STATE OF IDAHO
DEPARTMENT OF WATER RESOURCES
BENEFICIAL USE FIELD REPORT

Permit No: 33-7159
Exam Date: 7/23/1992

Date: May 25, 2005
To: Water Right File 33-7159
From: kwilson
Re: Field Report Narrative

RE: Jake Amy - New Energy c/o David Snedigar Hydropower permits

HYDROPOWER

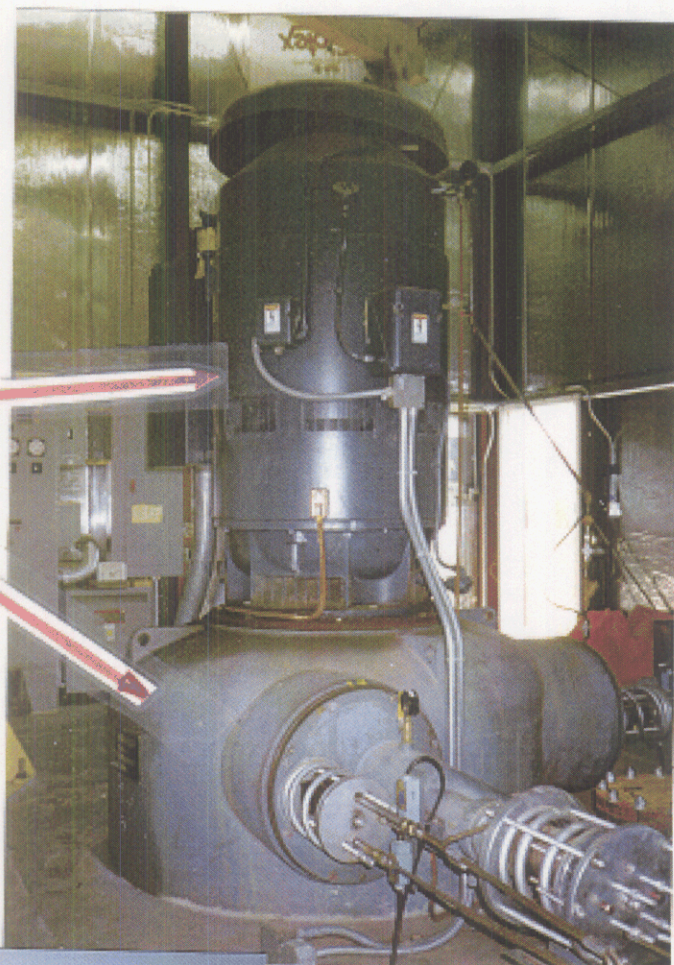
DIVERSION DAM with 16" mainline to hydropower plant open
discharge into ditches for irrigation or discharged into Little Lost
River.

The system consists of two diversion dams one on Deep Creek and one on Black Creek each with a 16-inch discharge pipeline. These two discharge pipes are combined into a common 16-inch pipeline to the power plant with open discharge into ditches. The water can then be used for irrigation or discharge into Little Lost River.

Stream channel calculations (Deep Creek or Black Creek), and the pipeline capacity exceed the permitted flows, and the hydropower efficiency is greater than 60 percent. Therefore, I recommend licensing 33-7159 for Power at the permitted amount of 0.80 cfs.
